Amendments to the Drawings:

The attached annotated sheets of drawings include changes to FIGS. 1, 2, and 12 and shows the changes to be made to the original sheets including FIGS. 1, 2, and 12.

FIG. 1

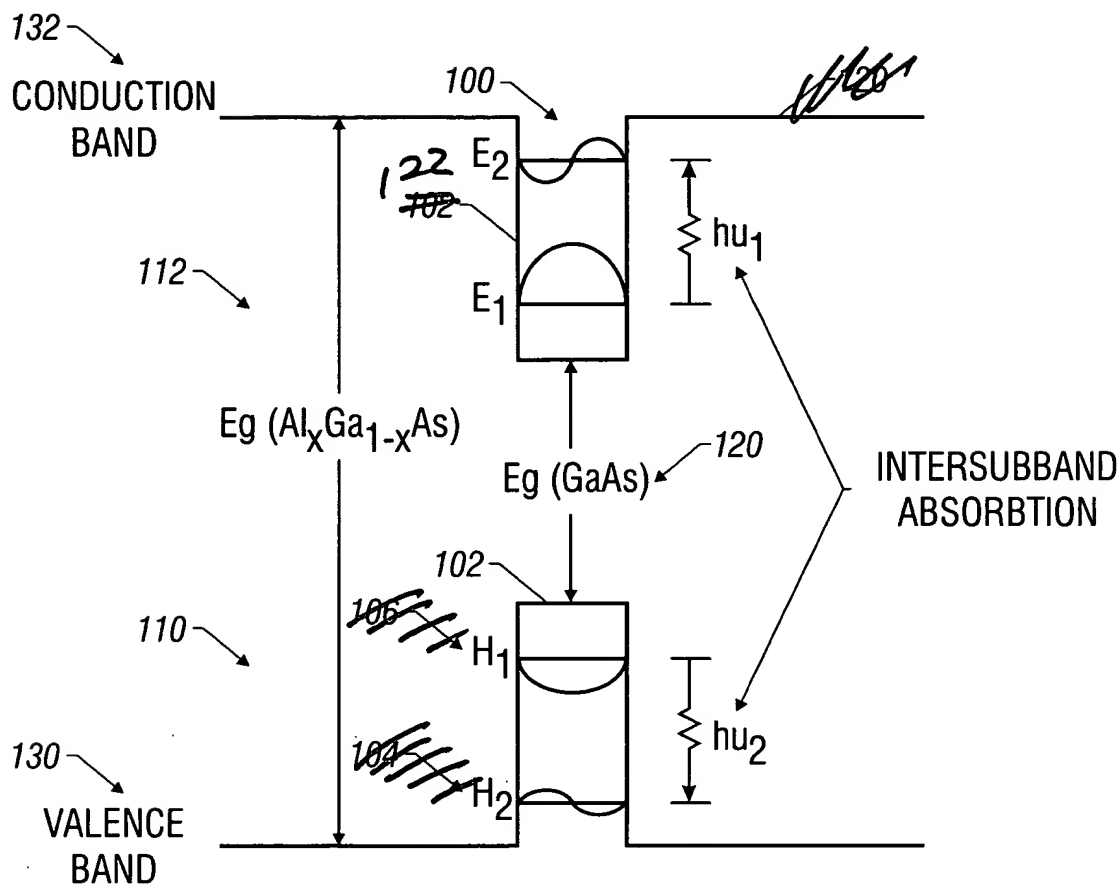
In FIG. 1, incorrect labels have been deleted or modified. In addition, "Prior Art" has been added per Examiner's requirement.

FIG. 2

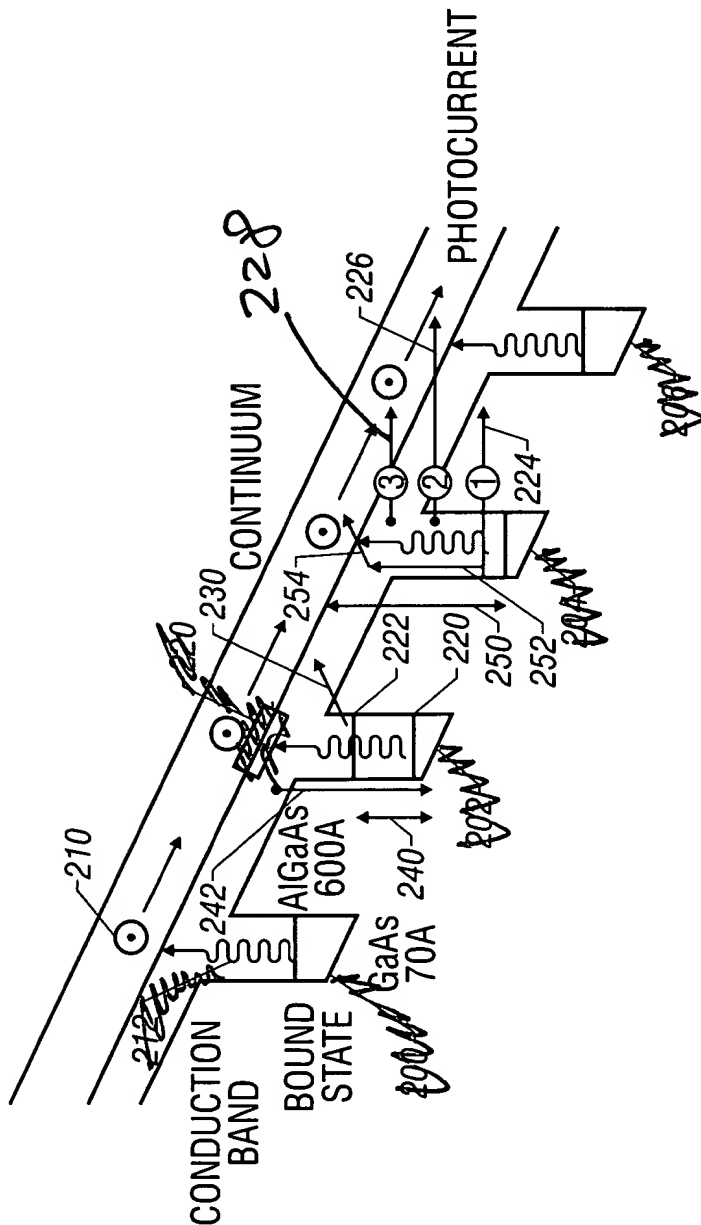
In FIG. 2, incorrect labels have been deleted. A label of "228" has been newly added to conform to the textual description. In addition, "Prior Art" has been added per Examiner's requirement.

FIG. 12

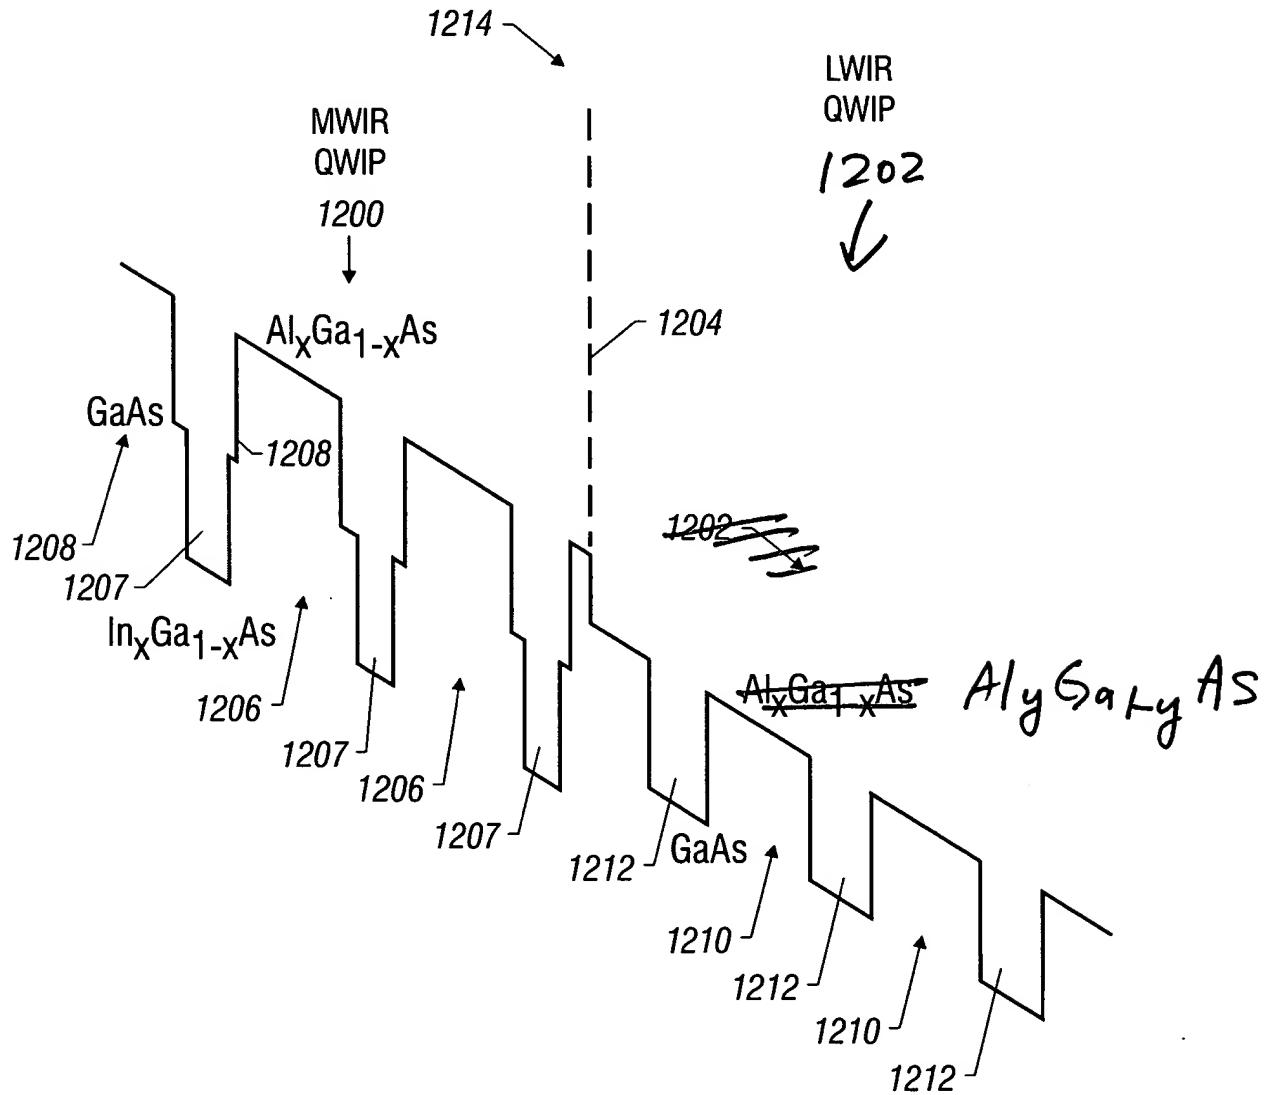
In FIG. 12, the position of label "1202" has been changed. In compliance with the examiner's suggestion and requirement, the composition label of the barrier layers for the LWIR QWIP 1202 has been modified to be different from that of the MWIR QWIP 1200.
